35/13-05L 10 Laurel Parkway
Chevy Chase Historic District

SUBJECT: Historic Area Work Permit #_382849_

EXPEDITED
HISTORIC PRESERVATION COMMISSION STAFF REPORT

PROPOSAL: Driveway and retaining wall alterations

10 Laurel Pkwy - driveway ^{2 feet} narrower
than shown on previous plan

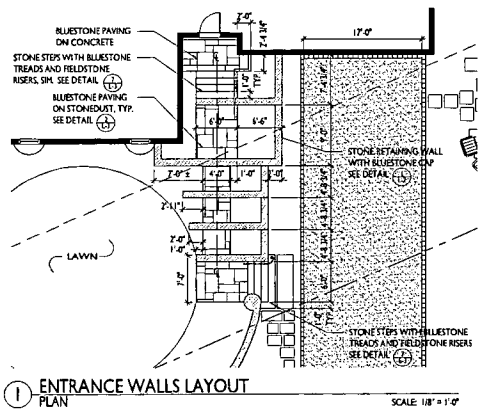
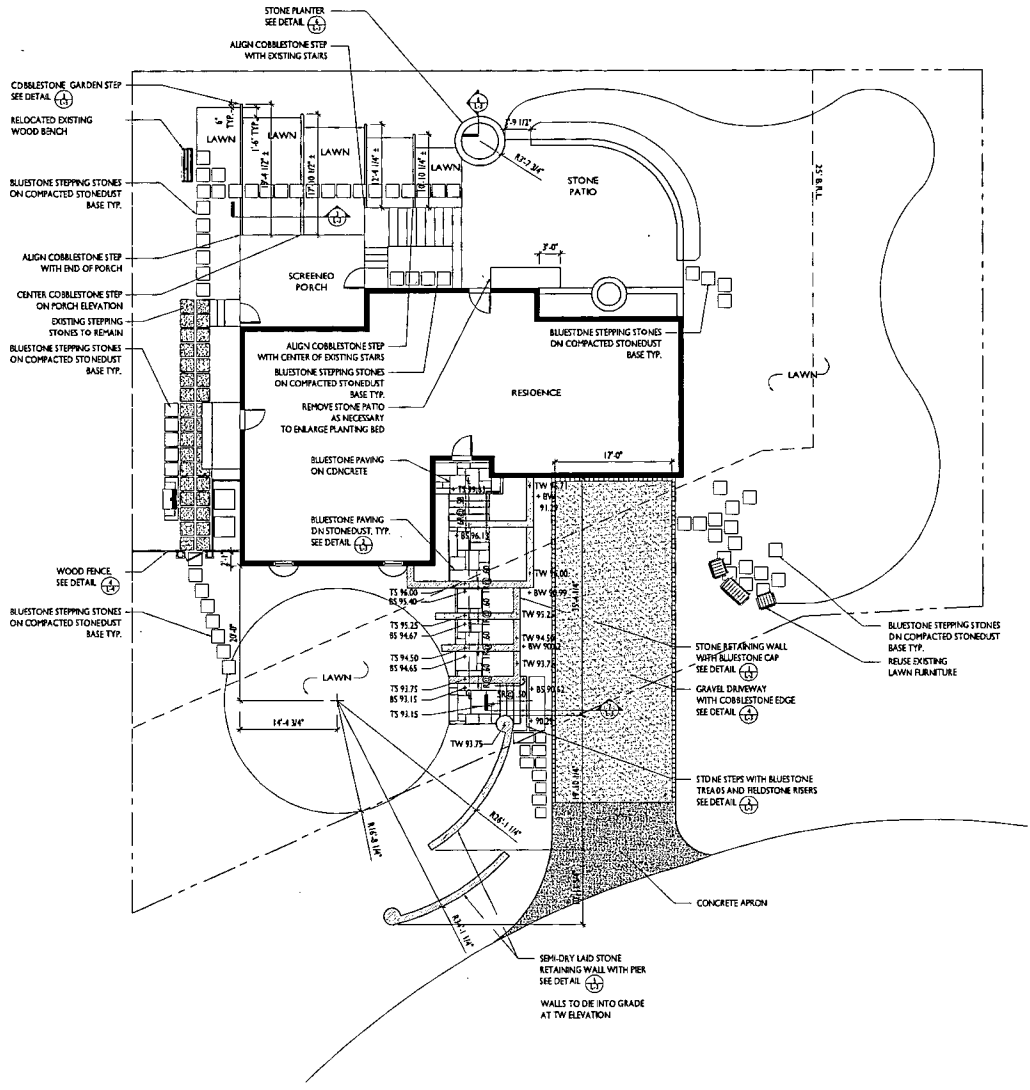
We had originally relied on the plat for the driveway width so it appears on your plan as 19' 10 3/4" (after a 2' requested widening), after confirming this in the field we discovered that the existing driveway is 16' wide. We proposed to CCV to widen the gravel portion to 17' with a 6" cobble border on each side, therefore a total width of 18' down the length of the driveway. That was the only change.
